# Manual Update Sheet

Document Being Updated: *TMS320C6000 Peripherals Reference Guide*

Literature Number Being Updated: SPRU190D

This Manual Update Sheet (SPRZ122C) describes changes for the *TMS320C6000 Peripherals Reference Guide* (SPRU190D).

*Figure 6–16. Linked EDMA Transfer*

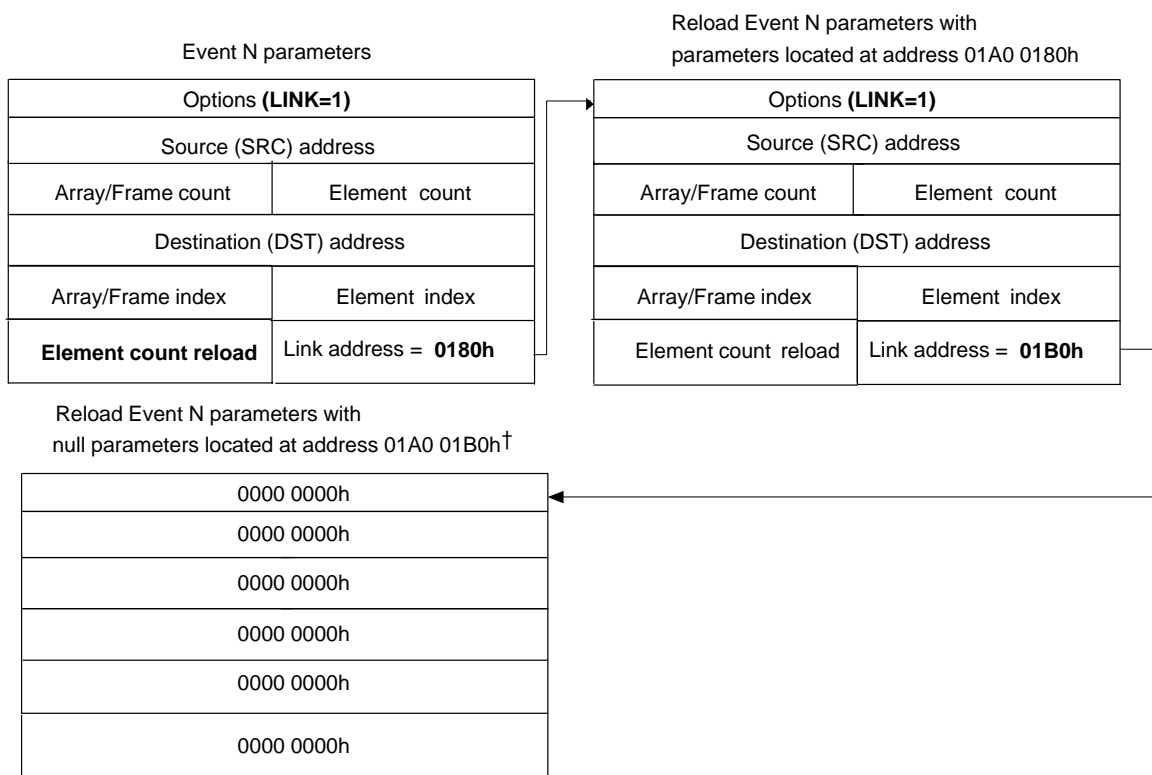
6–39            Change “Elementary count reload” to “Element count reload” in Figure 6–16:

*Figure 6–17. Terminating EDMA Transfers*

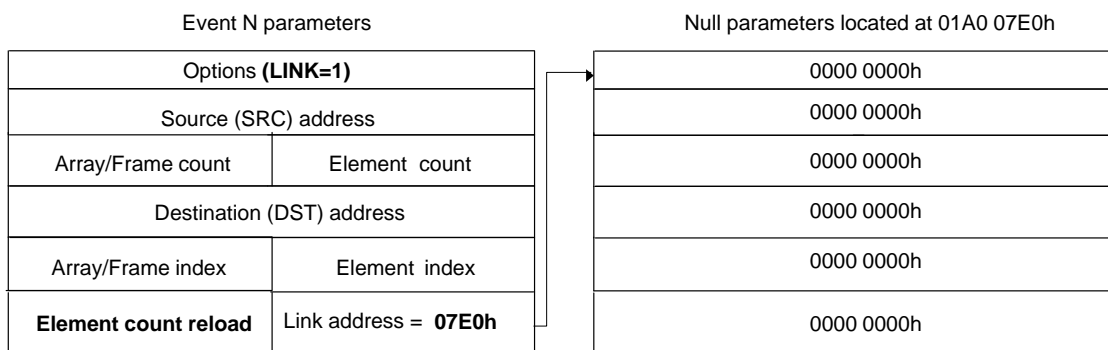
6–41            Change “Elementary count reload” to “Element count reload” in Figure 6–17:

Figures 7-11. *HPI32 Read Timing ( $\overline{\text{HAS}}$  Not Used, Tied High) for C64x only*

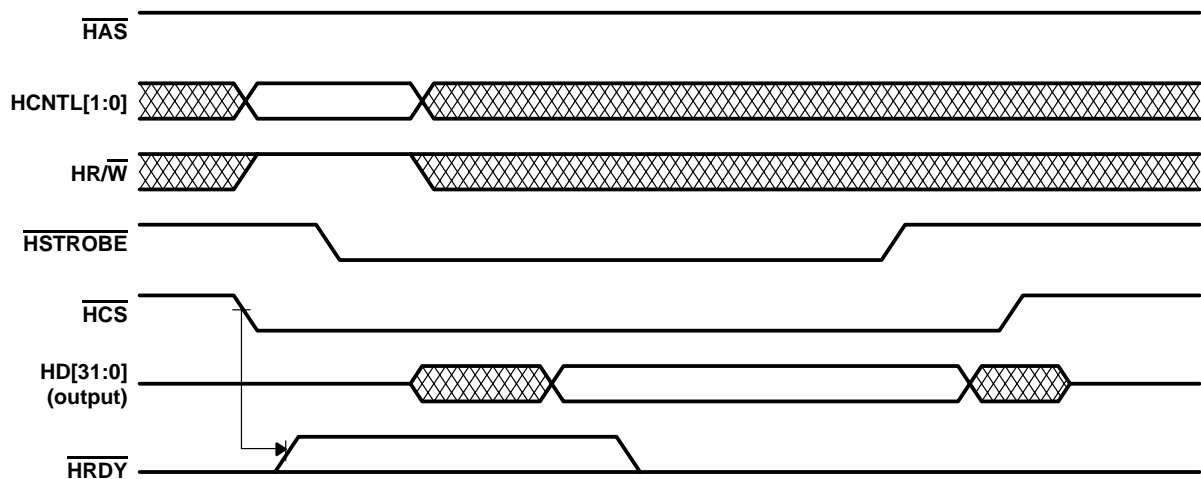
7-22              Change Figure 7-11 (delete  $\overline{\text{HRDY}}$  case 2 waveform):

Figures 7-12. HPI32 Read Timing ( $\overline{\text{HAS}}$  Used) for C64x only

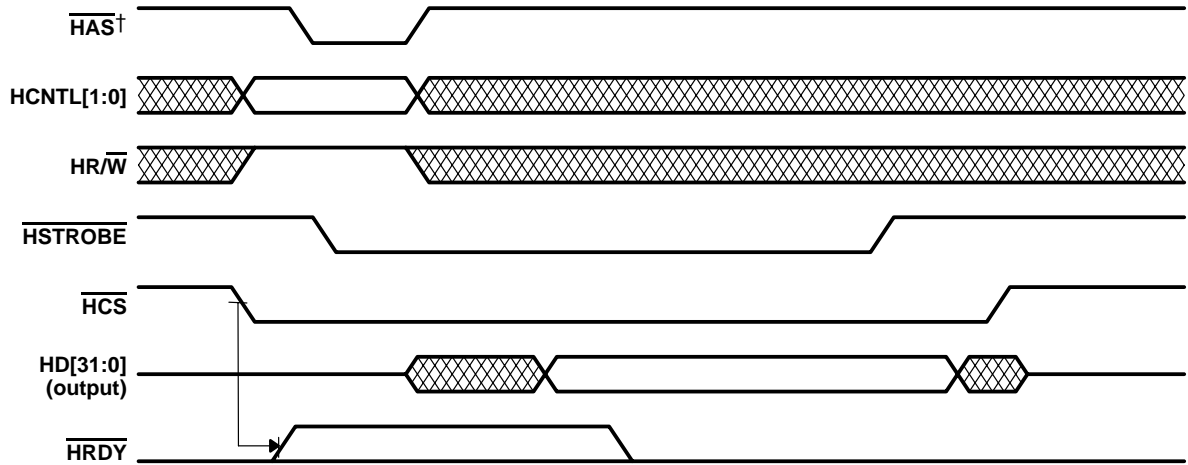
7-22            Change Figure 7-12 (delete  $\overline{\text{HRDY}}$  case 2 waveform):

Figure 7-13. HPI Write Timing ( $\overline{\text{HAS}}$  Not Used, Tied High) for C64x only

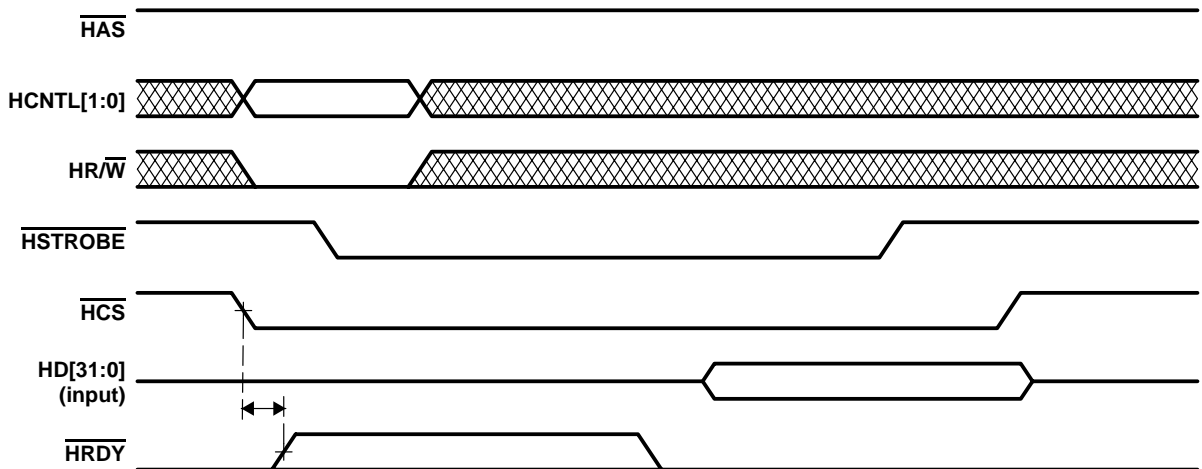
7-23            Change the  $\text{HR}/\overline{\text{W}}$  and  $\overline{\text{HRDY}}$  waveforms in Figure 7-13:

Figure 7-14. HPI Write Timing ( $\overline{\text{HAS}}$  Used) for C64x only

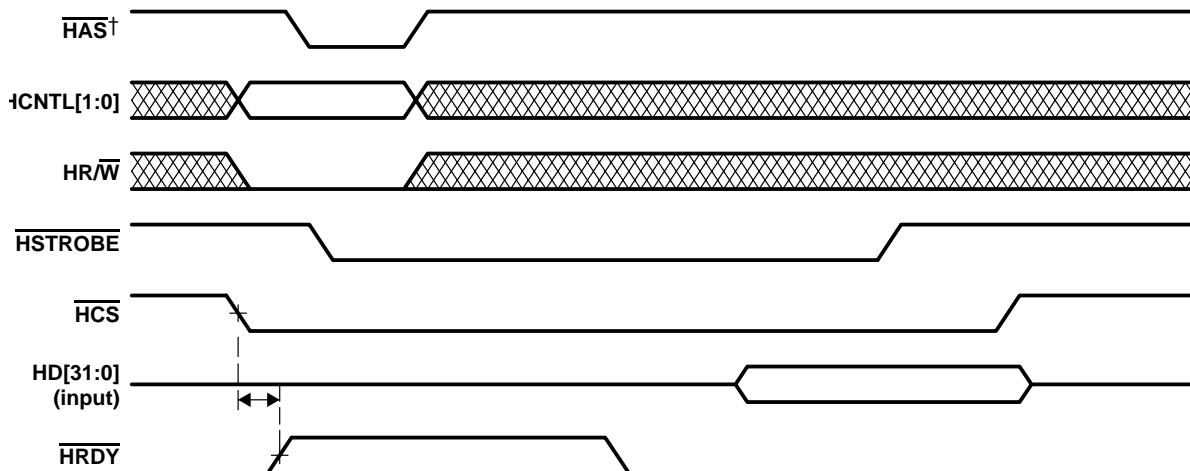
7-23 Change the  $\overline{\text{HR}}/\overline{\text{W}}$  and  $\overline{\text{HRDY}}$  waveforms in Figure 7-14:

Figure 8-22. Expansion Bus Master Writes a Burst of Data to the DSP

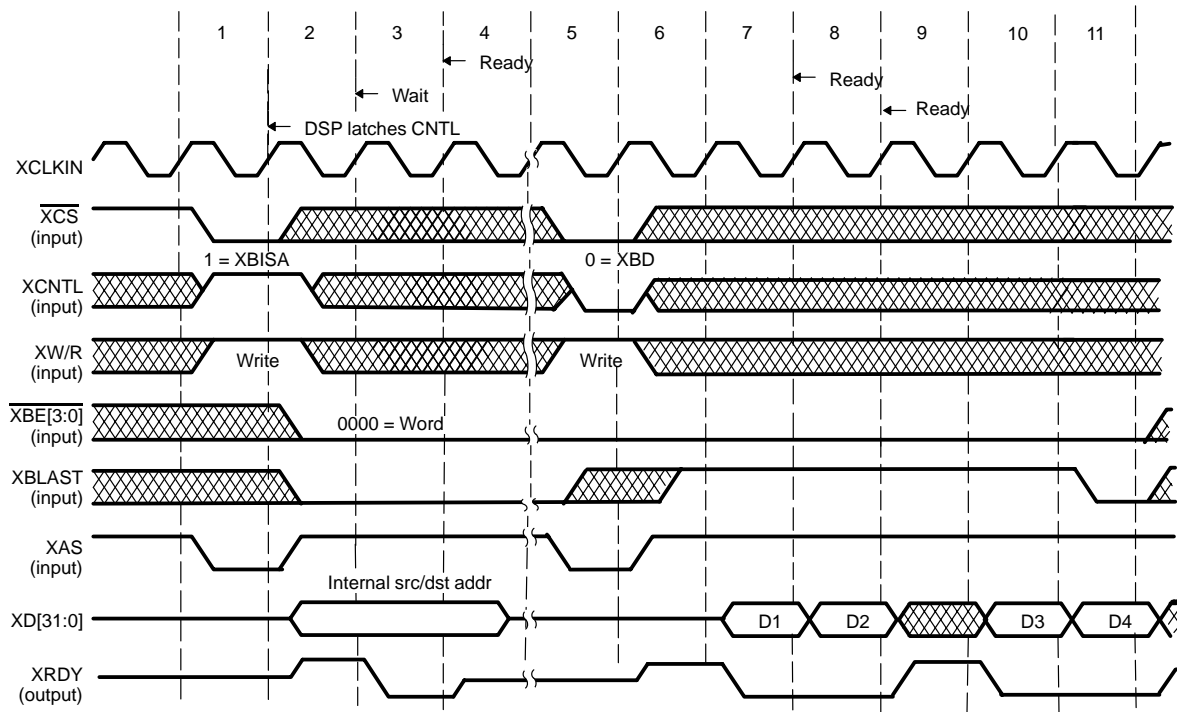
8-38            Change Figure 8-22 to show the XRDY signal in high impedance (*not* high) in clock cycle four and five. The DSP should start driving the XRDY signal during the sixth clock cycle.

Figure 8-23. The Bus Master Reads a Burst of Data From the DSP

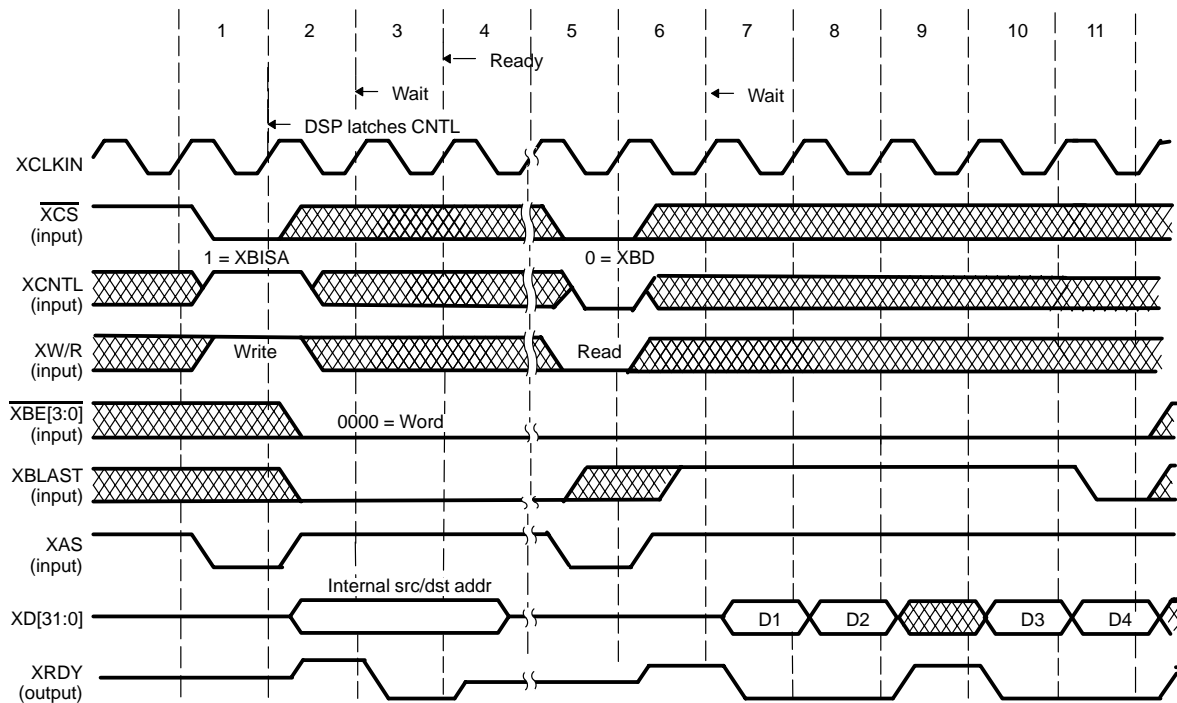
8-40            Change Figure 8-23 to show the XRDY signal in high impedance (*not* high) in clock cycle four and five. The DSP should start driving the XRDY signal during the sixth clock cycle.

*Figure 10–8. EMIF Global Control Register (GBLCTL)*

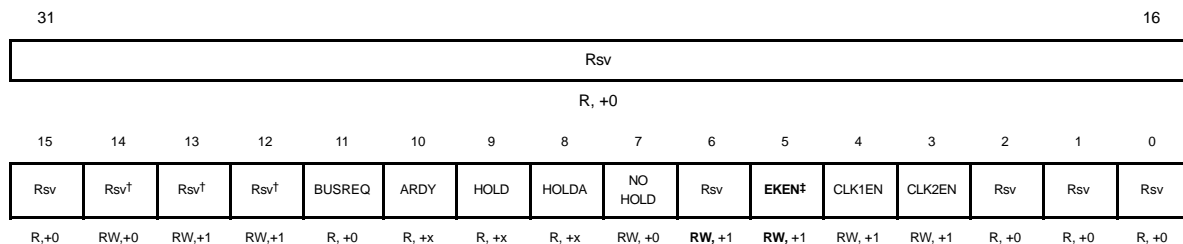
10–15            Change the C621x/C671x bits 6 and 5 read/write fields and the footnotes in Figure 10–8:

† The reserved bit fields should always be written with their default values when modifying the GBLCTL. **Writing other values to these fields may cause improper operation.**

*Figure 10–11. EMIF SDRAM Control Register (SDCTL)*

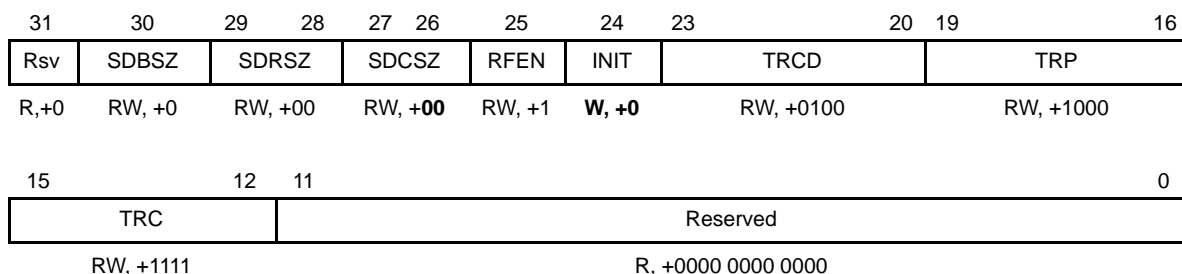
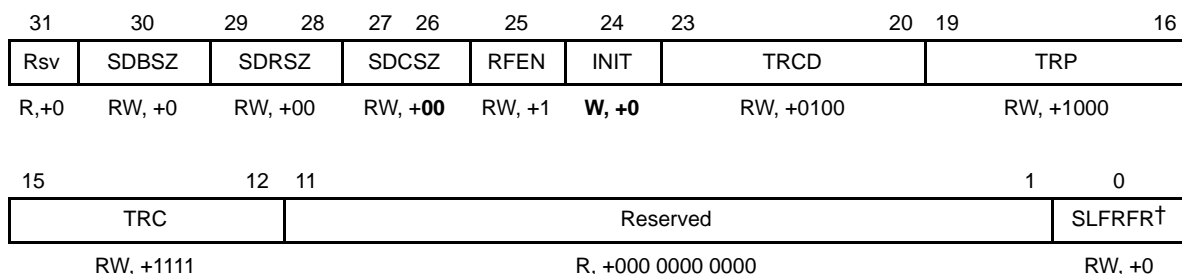
10–23            Change the SDCSZ (bits 27–26) and INIT (bit 24) read/write fields in Figure 10–11:

*Figure 10–39 TMS320C64x SBSRAM Interface*

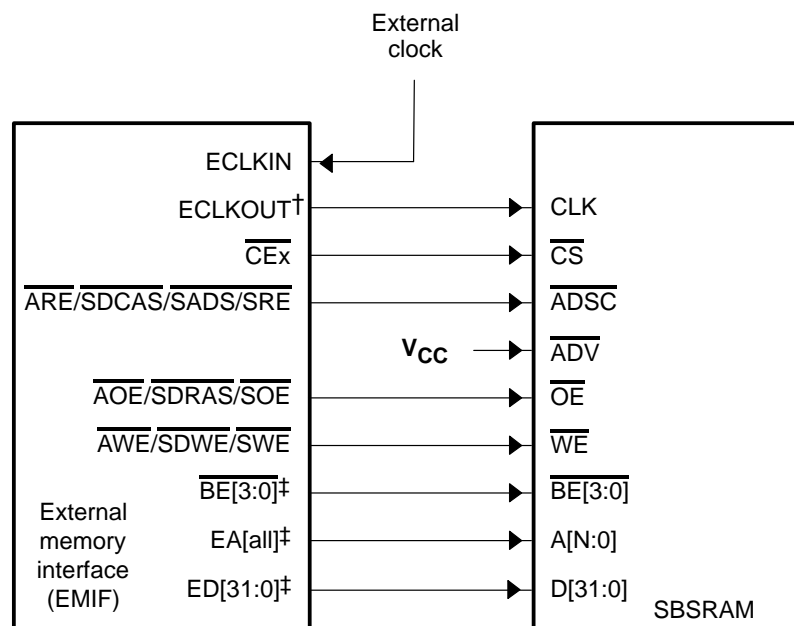
10–75            Change the input on  $\overline{ADV}$  and the footnote in Figure 10–39:

† ECLKOUTx used is selected by the SNCCLK bit in the CExSEC register.  
‡ For interface to a 64-bit data bus, BE[7:0], EA[all], and ED[63:0] are used.  
For interface to a 16-bit data bus, BE[1:0], EA[all], and ED[15:0] are used.

Figure 10-42. TMS320C64x SBSRAM Six-Element Read

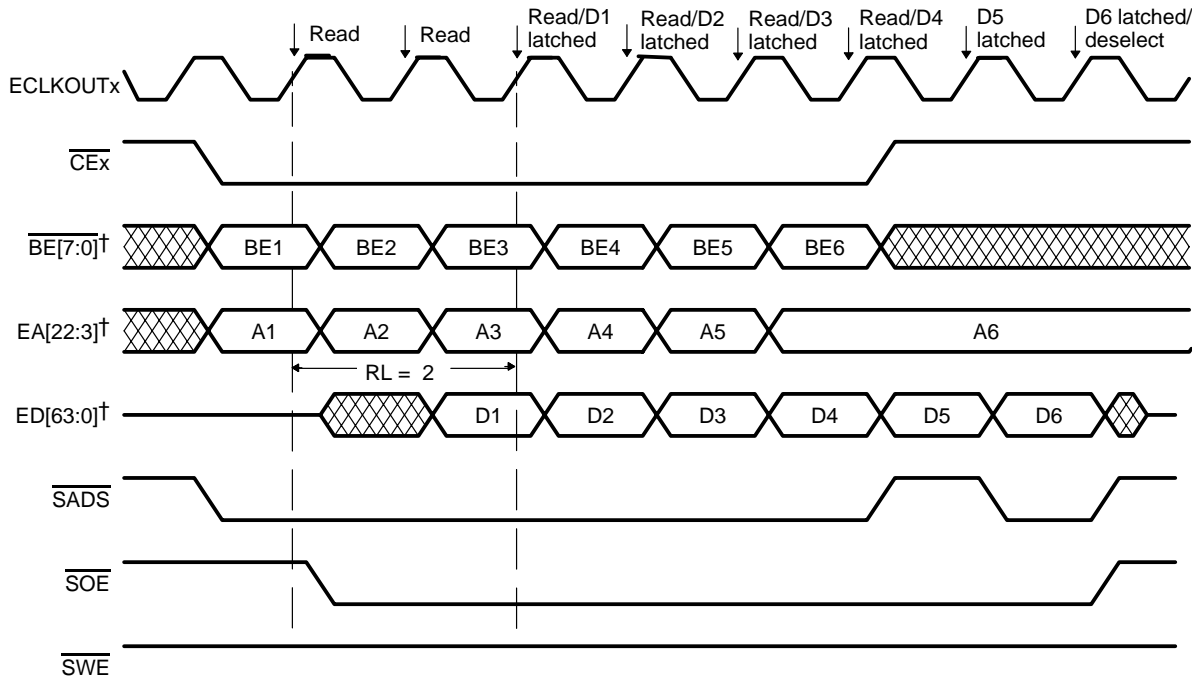
10-79 Delete the PDT signal and change the footnotes in Figure 10-42:

† For EMIFB,  $\overline{\text{BE}}[1:0]$ , EA[20:1], and ED[15:0], respectively, are used instead.

Figure 10-45. TMS320C64x SBSRAM Six-Element Write

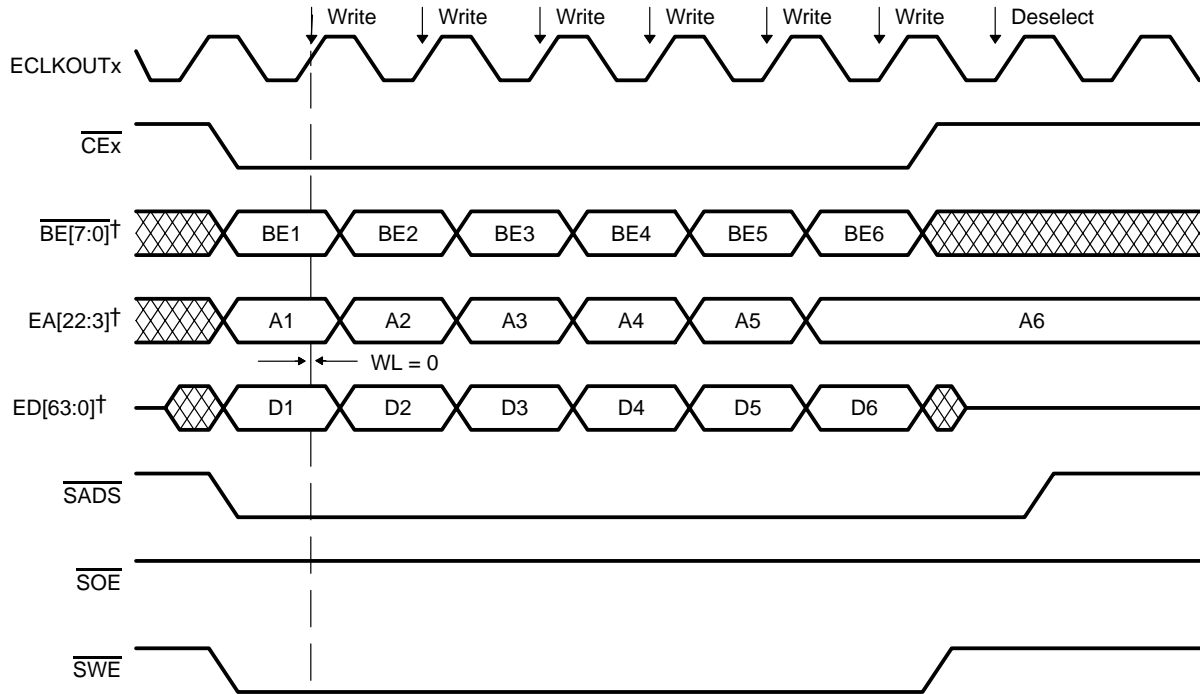
10-82 Delete the PDT signal and change the footnotes in Figure 10-45:

† For EMIFB,  $\overline{\text{BE}}[1:0]$ ,  $\overline{\text{EA}}[20:1]$ , and  $\overline{\text{ED}}[15:0]$ , respectively, are used instead.

Figure 10-46. TMS320C64x ZBT SRAM Interface

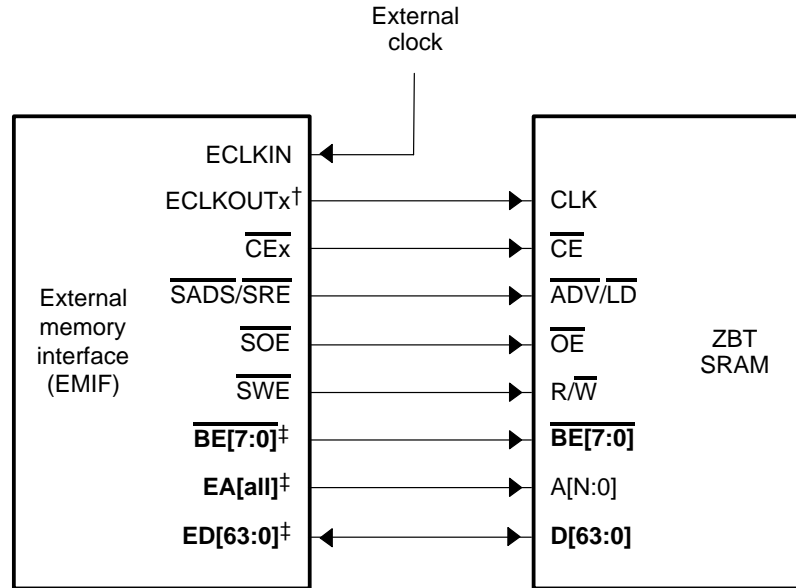
10-84            Change the signal names and footnote in Figure 10-46:

† ECLKOUTx used is selected by the SNCCLK bit in the CExSEC register.

Figure 10-47. TMS320C64x ZBT SRAM Six-Element Write

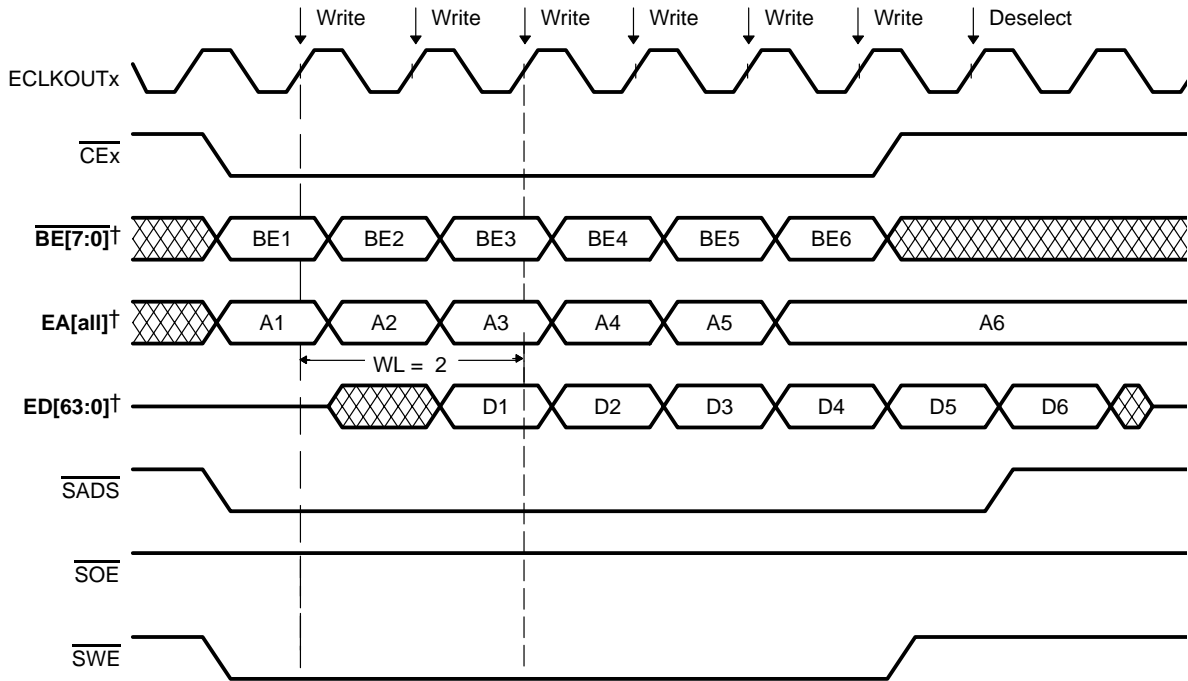
10-85 Delete the PDT signal and change the signal names and footnotes in Figure 10-47:

† Figure shows 64-bit interface. The MTYPE field selects the interface type to be 8-, 16-, 32-, or 64-bits wide.  
 For 32-bit interface,  $\overline{BE}[3:0]$ , EA[all], and ED[31:0] are used  
 For 16-bit interface,  $\overline{BE}[1:0]$ , EA[all], and ED[15:0] are used

Figure 10-50. TMS320C64x Glueless Synchronous FIFO Write Interface

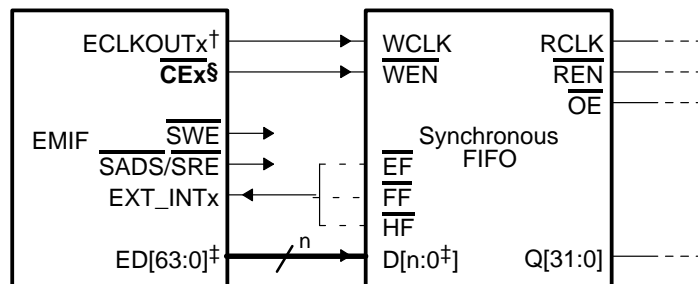
10-87 Change the figure title, signal name, and footnote in Figure 10-50:

† ECLKOUTx used is selected by the SNCCLK bit in the CExSEC register.
